Roma Brisbane Pipeline
Review of Pipeline Capacity and Tariff Adjustment
Mechanisms

12 December 2006

Sleeman Consulting

Figure 1: Modelled and Predicted Capacities V's GHV

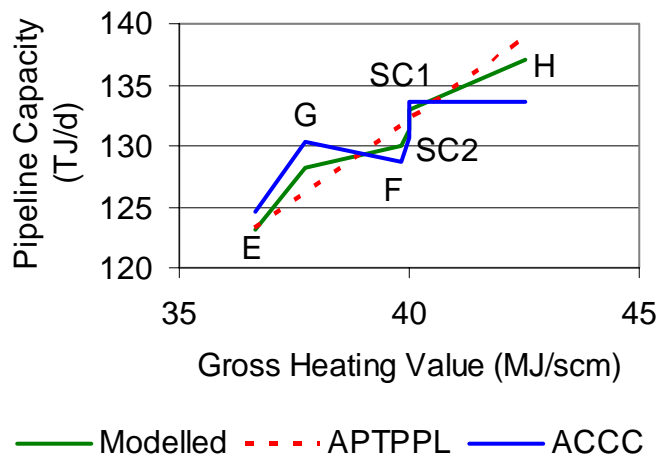
In Figure 1, pipeline capacity predictions developed using the AFTPPL adjustment mechanism appear as a straight line. This is because the AFTPPL mechanism is a linear function of Gross Heating Value.

- by inspection of the green (as modelled) lines, there is nor simple relationship between the capacity of a gas pipeline and either Gross Heating Value or Wobbe Index;
- as the gas quality declines (whether measured in terms of Gross Heating Value or Wobbe Index) so too will the transportation capacity of a given pipeline; and
- both the APTPPL and the ACCC adjustment mechanisms are indicative of the impact upon pipeline capacity of changes in gas quality.

- i) It is evident from Figures 1 and 2 that changes in gas composition and quality have a material impact upon the capacity of a gas pipeline to transport gas. Impacts of this nature will be particularly important for a gas pipeline that operating at or near capacity, particularly if it accepts gas of varying qualities from multiple sources.

Figure 2: Modelled and Predicted Capacities V's Wobbe Index

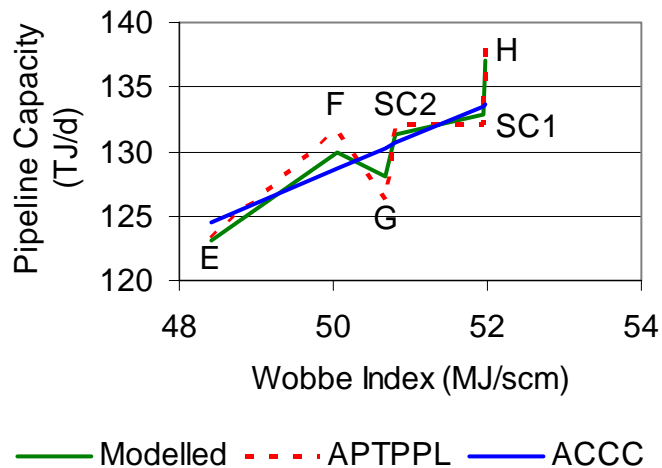
In Figure 2, pipeline capacity predictions developed using the ACCC adjustment mechanism appear as a straight line. This is because the ACCC mechanism is a linear function of Wobbe Index².

Figure 3: Reproduced from Venton Letter of 20 September 2006

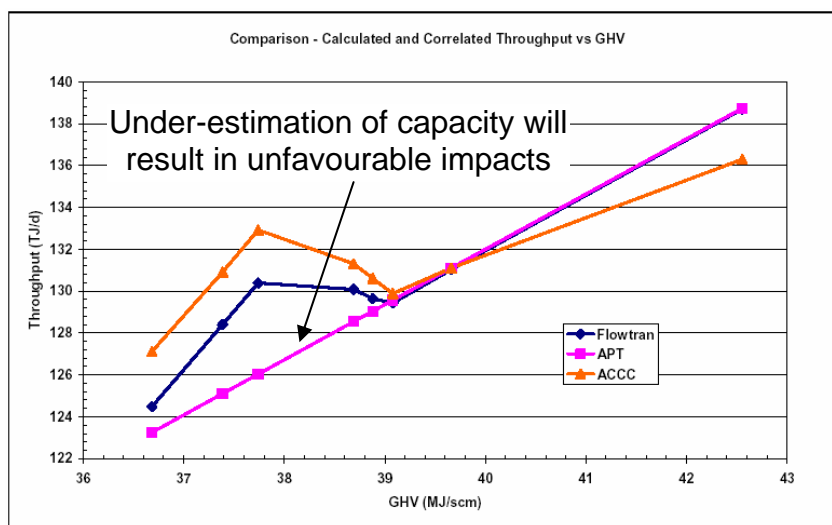
Venton has indicated³ that the adjustment mechanism proposed by APTPPL is more favourable (ie, leads to a smaller increase in gas transportation costs) than the mechanism proposed by the ACCC.

For Venton's suggestion to be correct, the APTPPL adjustment mechanism will (for gases with a Gross Heating Value below 40 MJ/m³) need to overestimate capacity relative to the ACCC adjustment mechanism.

On the contrary, information presented by Venton (reproduced below as Figure 3) and calculations performed during preparation of this Report (the results of which are presented in Table 2) show that the opposite applies.

The impact of the APTPPL adjustment mechanism is marginally more unfavourable than the impact of the proposed ACCC adjustment mechanism. However, the APTPPL mechanism:
